**Hunterston B - Return to service safety case for Reactor 4 following core inspection results in 2018 - NP/SC 7785 - Civil engineering assessment**

Assessment Report ONR-OFD-AR-18-085  
Revision 0  
April 2019

Figure 2 – New PCPV Model idealisation

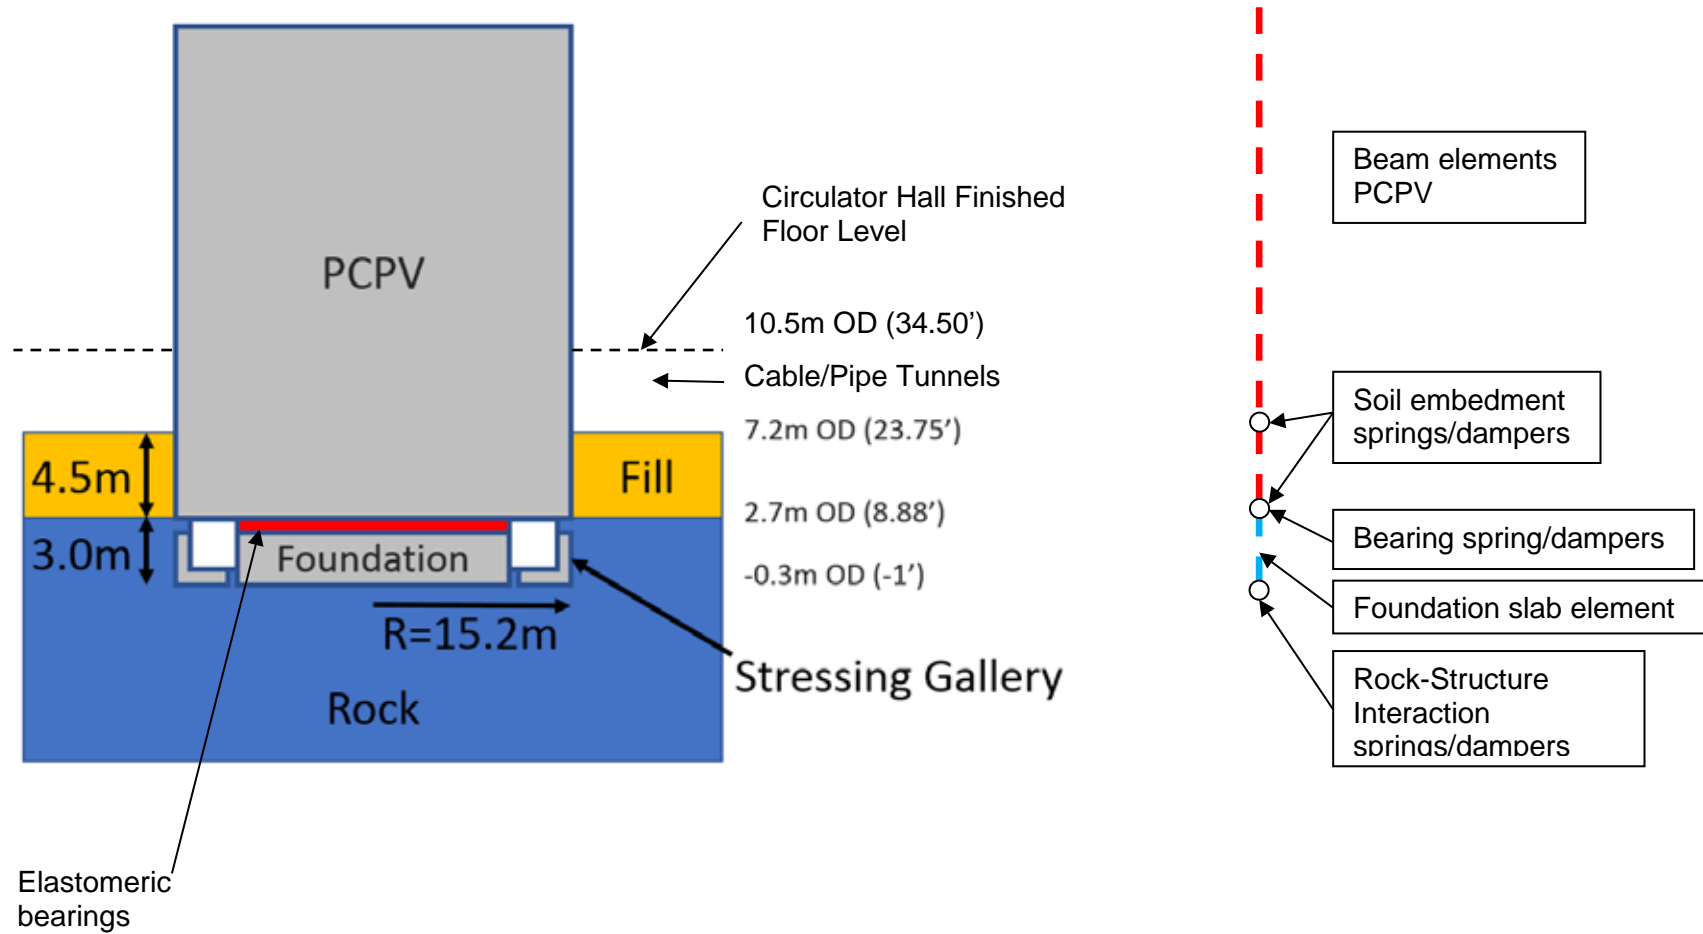
71. The preliminary PCPV model is idealised in Figure 2. It is a development of the first seismic “buildings model” produced in support of PSR1. This “legacy” model (see Figure 1) was developed to perform a BE seismic assessment of the structural members of the Reactor Building and Turbine Hall. It included representations of the PCPVs, Central Block, Circulator Hall and ancillary buildings. The legacy model was used to derive acceleration time histories, which were used as the basis for seismic assessments of the graphite cores.
72. One of the key features of the PCPV design is the presence of neoprene bearing pads between the underside of the vessel and the top of the foundation disk. These

Figure 3 – Extracts from original construction drawings

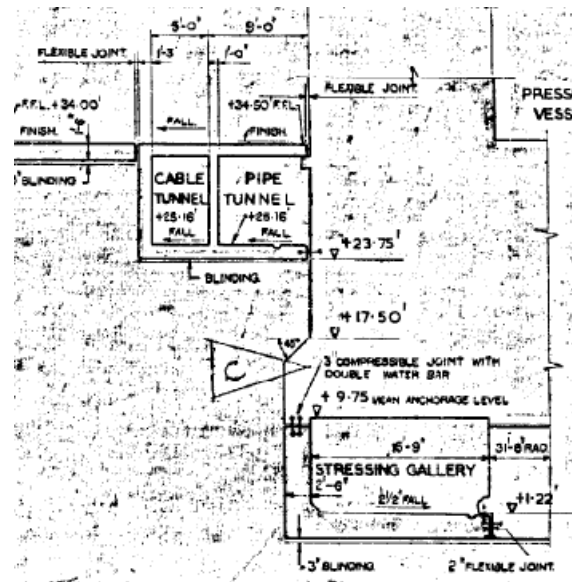
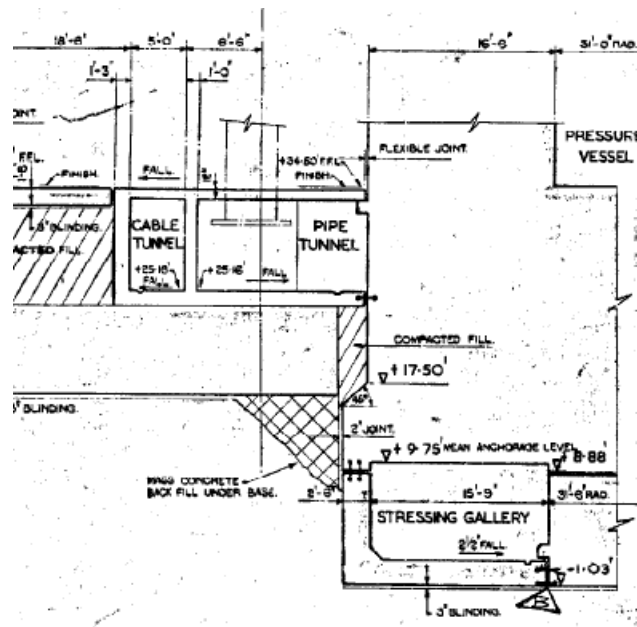
118. I challenged the assumption (ONR Query 14) that the UB backfill properties were based on well-compacted fill rather than on mass concrete. In its response, NGL referred to the original drawings, which show joint and blinding details that would be unnecessary if mass concrete fill had been used (see Figure 3). I agree that the availability of suitable fill material, combined with the relative cost and difficulty of using mass concrete, mean that the use of concrete was unlikely. Taking into account the additional evidence provided by the construction photographs, I agree with NGL's judgement that the backfill material is likely to be compacted site-won soil.

119. Drawings HIN/R/3004 and 3008 included in Ref. 17 show there are substantial concrete pads used beneath four double column locations. At these locations, there is limited horizontal width of compacted backfill between the side of the PCPV and the column bases founded on rock, with local pinch points near the corners of the bases. In its response to ABSC Query 9, NGL did not agree that these pinch points would restrain the PCPV by more than the UB backfill properties, as well compacted soil may be more difficult to achieve in narrow gaps. I agree with ABSC's judgement, based on the relatively small estimated displacement of 3 mm, that the UB case is sufficient to bound any potential increase in stiffness arising from this detail.

Figure 4 - SRS comparison at core boundary for PML synthetic input motion for Legacy and Preliminary PCPV models (After Ref. 17, Figure 33)

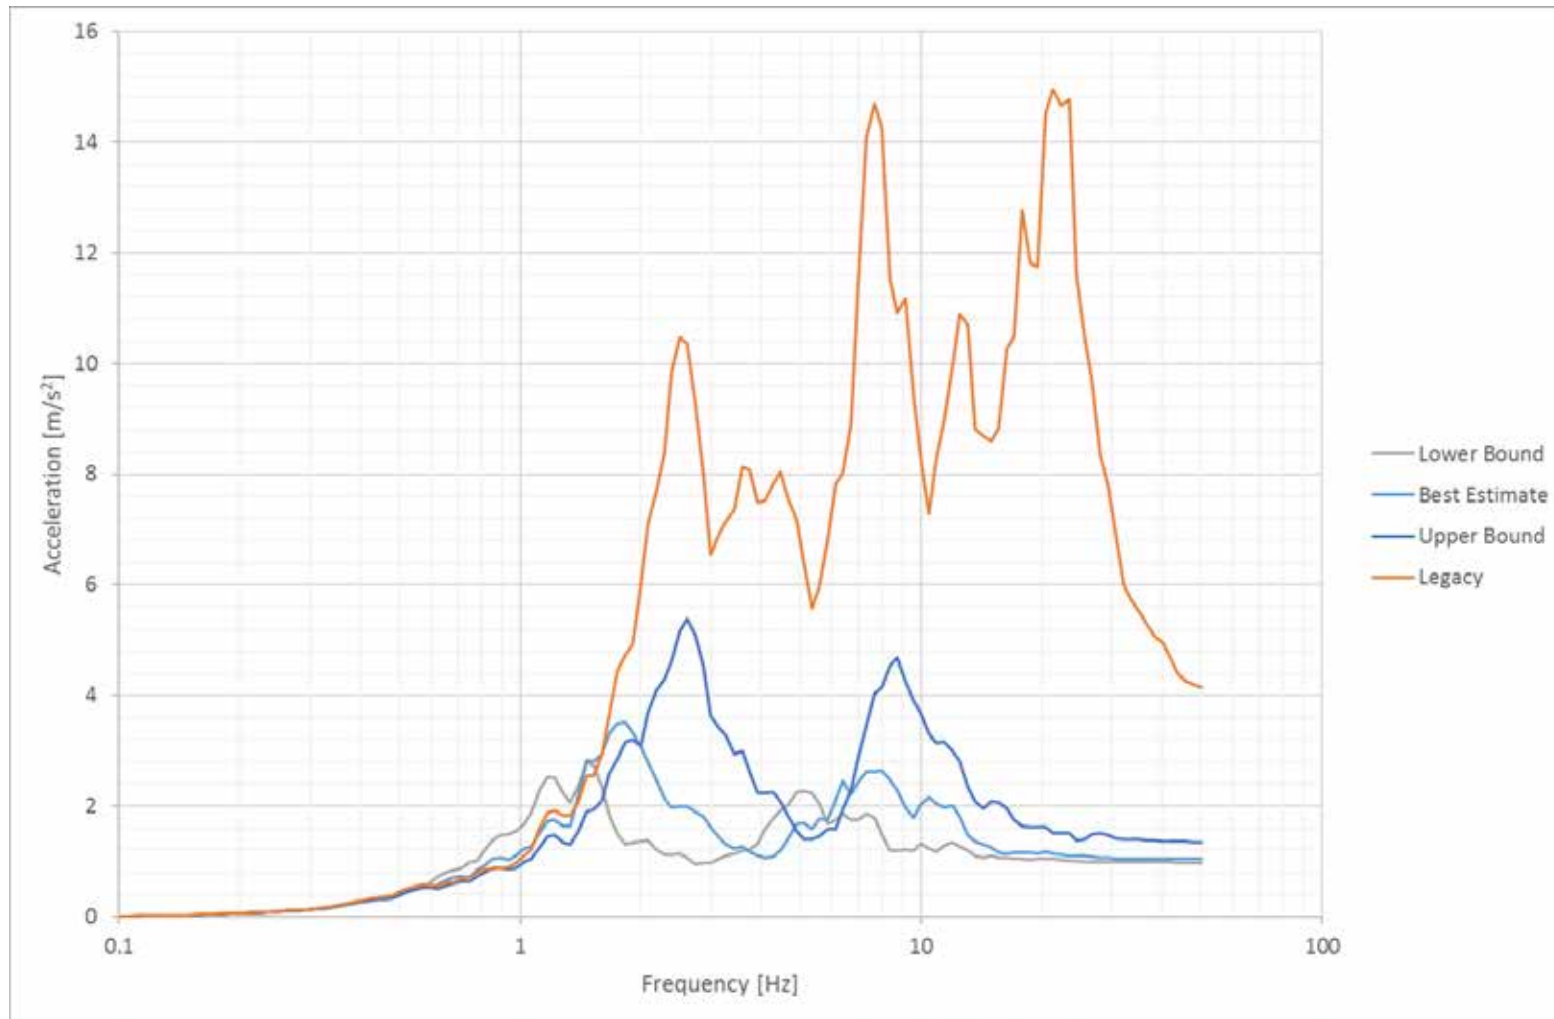
163. I consider it is apparent from Figure 4 that for the BE case, using the synthetic PML seismic input motion, that the spectral acceleration at the core boundary for the preliminary model is less than that for the legacy model at all frequencies above about 1.5 Hz. At lower frequencies, the two models gave similar core boundary accelerations.

164. Figure 4 also shows results for LB and UB sensitivity cases (i.e. in which RSI, bearing and backfill properties are all set to their individual LB or UB values simultaneously). These plots show that the core boundary accelerations are greater in the 2 to 5 Hz region for the UB case compared with the BE case, but remain lower than for the legacy model. For the LB case, the spectral acceleration exceeds that for the legacy model below 1.5 Hz. As part of its response to ABSC Query 2 (Ref. 24), NGL provided further evidence in the form of core distortion scores (an example of which is given in Figure 7) that confirmed that the UB sensitivity case was the most onerous for core distortion. Based on the evidence presented, I am satisfied that the core response is not critical at frequencies below 1.5 Hz.

Figure 5 - Modified PML core boundary SRS (including legacy core boundary PML) for the BE preliminary model (After Ref. 17, Figure 34)

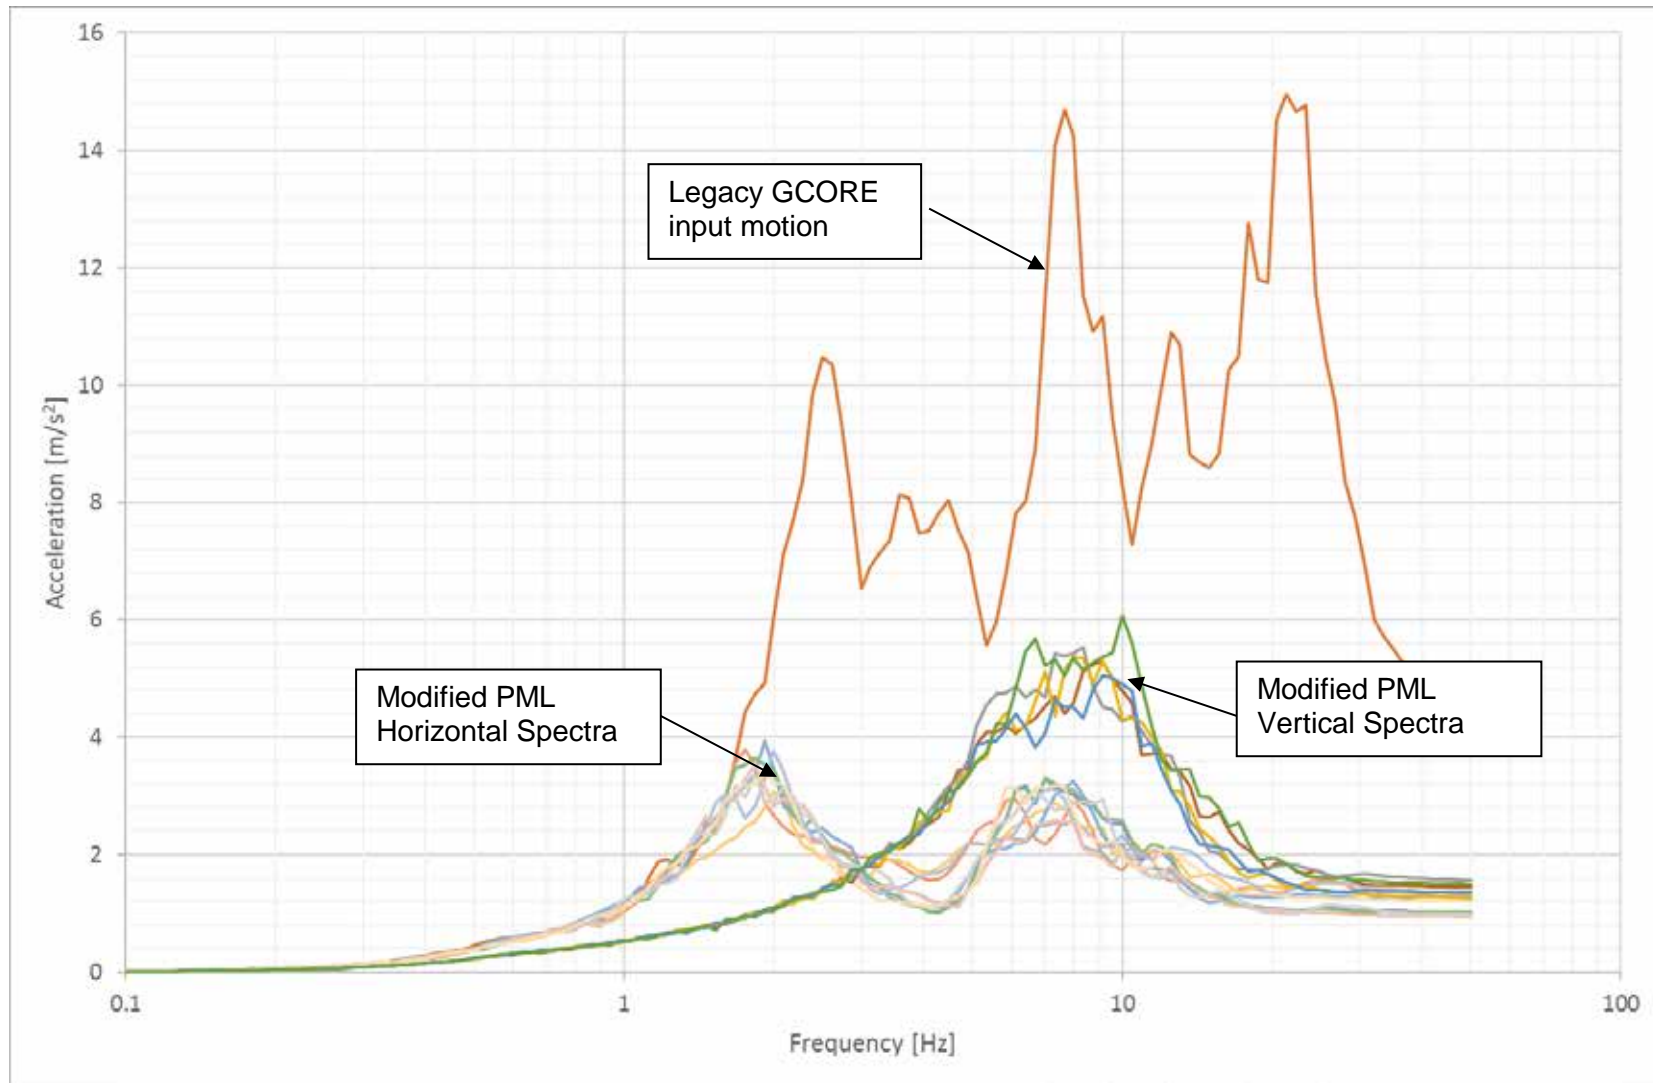
166. NGL claims that the core boundary accelerations calculated from the modified PML input motions are consistent with the synthetic PML input motion. For the modified PML input motion the response spectra at the core boundary for the BE case in all three directions are shown in Figure 5. The horizontal response spectra are generally similar, with accelerations of up to  $4 \text{ m/s}^2$  at approximately 2 Hz for the first peak and  $3 \text{ m/s}^2$  at around 8 Hz for the second peak. In the vertical direction, all the input motions give a similar magnitude response of approximately  $5 \text{ m/s}^2$  in the 7 to 10 Hz frequency range. I noted that the peak horizontal spectral acceleration in the important 2 to 3 Hz frequency range is similar between the BE synthetic PML input motion and the modified PML input motion. Some of the spectral accelerations for the modified PML exceed those for the synthetic PML at frequencies below about 2 Hz. I consider that

the results show that as regards accelerations of significance to core response, the legacy synthetic PML input motion is conservatively bounding and the licensee's claim has therefore been substantiated.

Figure 6 - SRS comparison at base of PCPV for Preliminary (prelim) and Final models (PML synthetic input motion) (after Ref. 24 - response to ABSC Comment 2i)

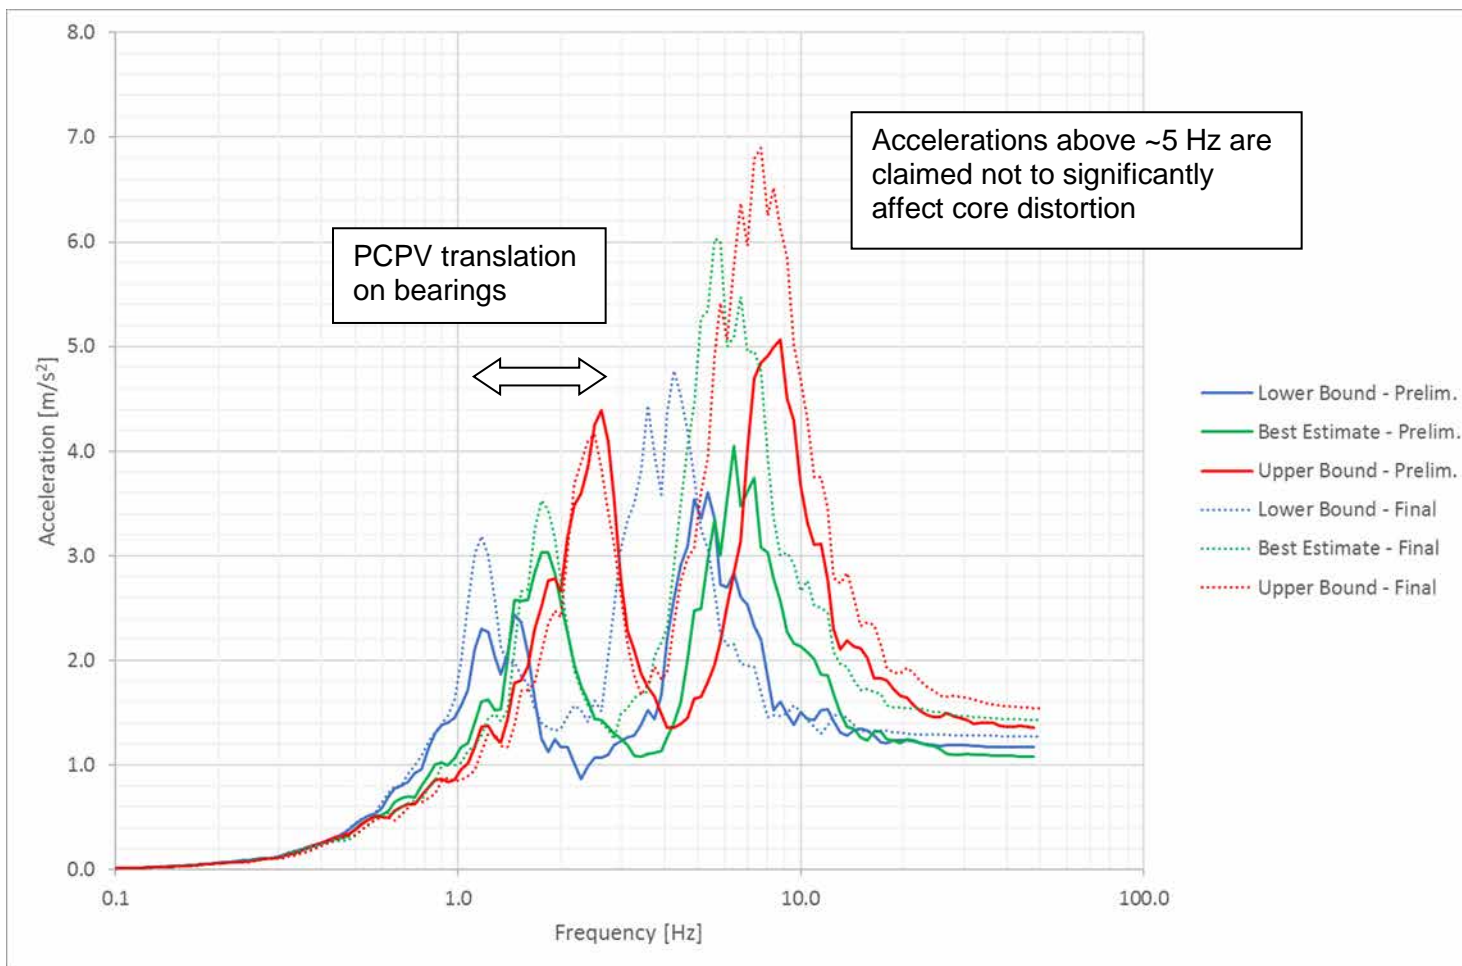
Further details supplied in response to this query (Ref. 24) have elicited information in the form of SRS comparisons for the preliminary and final models (e.g. Figure 6) and preliminary GCORE runs based on the final PCPV model output. These runs include graphs showing margins in relation to interstitial channel distortion (for examples see Figures 7 and 8). As it is not stated on the information provided, NGL has clarified (Ref. 34) that the core state assumed in these analyses was 931 SCB (in layers 3 to 8) and 400 DCB (in layers 4 to 6). It is understood that other core states have been analysed (including the inclusion of MCBs) and these gave similar results, but I consider this a matter for ONR's graphite assessment and outside the scope of this report.

173. The horizontal SRS presented in Figure 6 can be used to assess whether the modelling changes made by NGL to the preliminary model (described in Section 4.3.1.9) in order to create a final model are likely to have a more onerous effect on the core. For the BE case, the low frequency peak increased by around 17%, with the second peak increasing by around 50%. For the UB case, stated by NGL to be governing in GCORE, the low frequency peak is not significantly changed, but the second peak is increased by around 40%. The second peak is associated with the rocking mode, which NGL considers is not critical for core distortion. Although it appears that the effects of the changes to the model may be more onerous for the core, this can only be confirmed by sampling GCORE analysis results, samples of which I obtained as a result of raising queries with the licensee as described below.
